SUNDRY NOTICES AND REPORTS ON WELLS Do not use this form for proposals to drill or to re-enter an abandoned well. Use form 3160-3 (APD) for such proposals.

APACHE REQUESTS TO MODIFY / CHANGE THE ORIGINAL PLANS FOR THE INTERIM RECLAMATION (IR) FOR THE FOLLOWING WELLS. LEASE # NMLC029426B CROW FEDERAL 22H, E-9-17S-31E, 1680'FNL & 10'FWL, 3001541166 CROW FEDERAL 23H, E-9-17S-31E, 1650'FNL & 10'FWL, 3001541167 CROW FEDERAL 24H, E-9-17S-31E, 1620'FNL & 10'FWL, 3001541168 LEASE # NMLC029435B NFE FEDERAL 58H, E-8-17S-31E, 1672'FNL & 85'FEL, 3101543088

PLEASE SEE ATTACHED DIAGRAM OF REVISED PLAN.

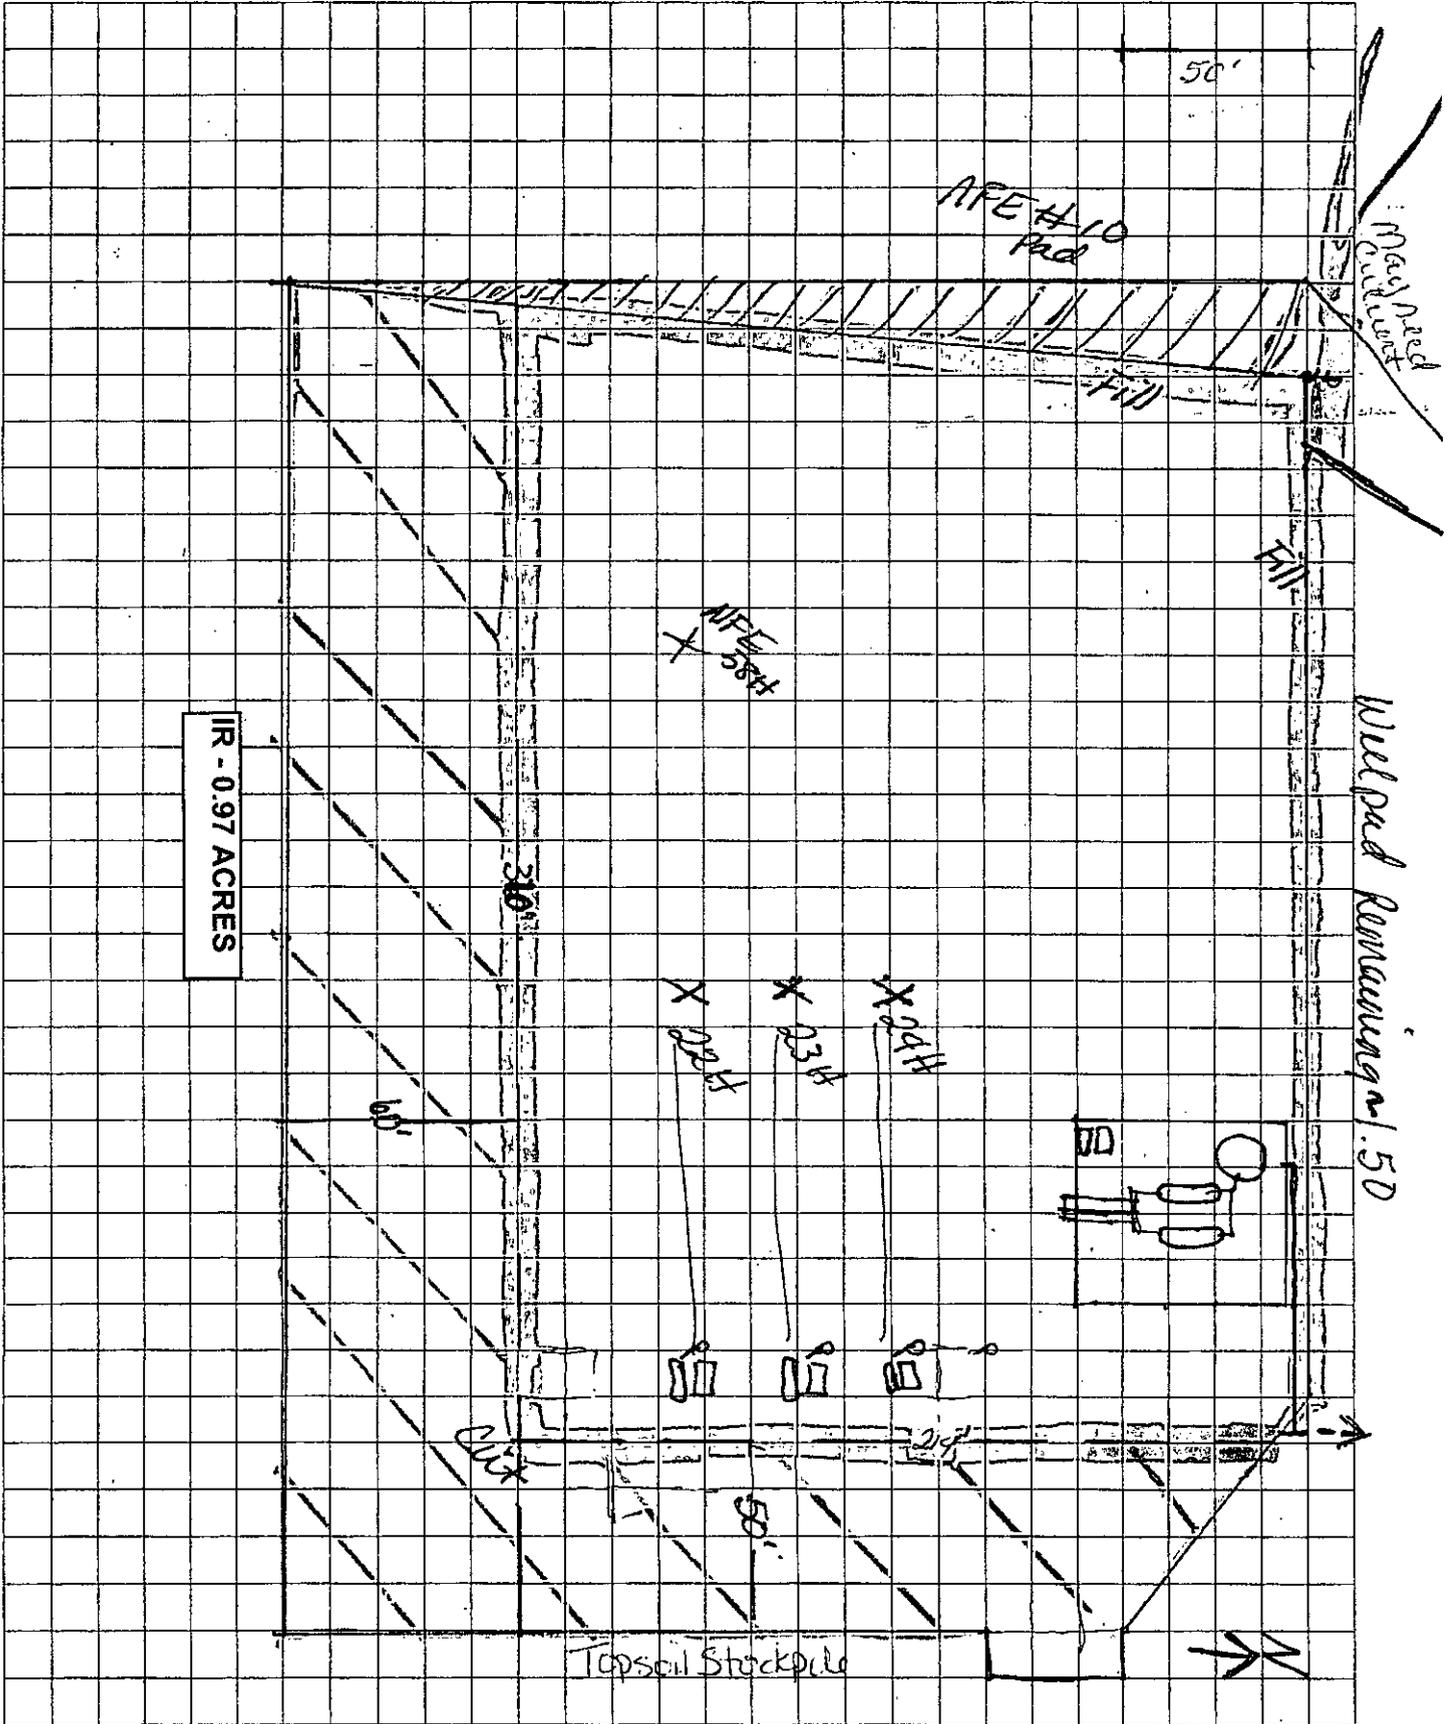
ORIGINAL PLANS DID NOT ACCOUNT FOR THE SATELLITE FACILITY LOCATED ON THE NORTH TO THE EAST OF THE ACCESS ROAD OR ELECTRICITY WITH PANELS FOR EACH WELL. NFE FEDERAL 58 WAS ADDED TO PAD WITH NO IR PLANNED. PLEASE SEE TABLE BELOW FOR ORIGINALLY PLANNED BEFORE AND AFTER ADDITIONAL NFE FEDERAL 58

IR WORK TO BE COMPLETED ? REMOVE ANY FRAC SAND AND UNUSED GRAVEL. PROPANE TANKS, IF STILL PRESENT, WILL BE REALIGNED TO MAXIMIZE THE IR ON THE EAST SIDE. CALICHE FREE OF ANY CONTAMINATION WILL BE REMOVED AND STOCKPILED FOR USE ON ROADS OR CONSTRUCTION OF WELL PADS. AREAS TO BE RECLAIMED WILL BE RECONTOURED TO MATCH SURROUNDING AREAS, THE TOPSOIL WILL BE DISTRIBUTED ACROSS ALL RECLAIMED AREAS, RIPPED ACROSS ANY SLOPED AREAS (<1% ANTICIPATED), AND SEEDED WITH BLM LPC SEED MIXTURE. WELL PAD WILL BE BERMED TO PREVENT CONTAMINANTS FROM LEAVING LOCATION IF AN UNDESIREABLE EVENT WAS TO OCCUR.

TYPE	PAD AS BUILT	ACREAGE	WELL PAD	REMAINING	ACREAGE
ORIGINAL	291 X 355 FEET	2.37	244 X 285 FEET		1.59
ORIGINAL	291 X 355 FEET	2.37	291 X 355 FEET		2.49
REVISED	291 X 355 FEET	2.37	214 X 310 FEET		1.52

THE EXTRA RECLAMATION WILL BE TRACKED BY ARCADIS WHICH IS 0.97 ACRES FOR THIS SITE.
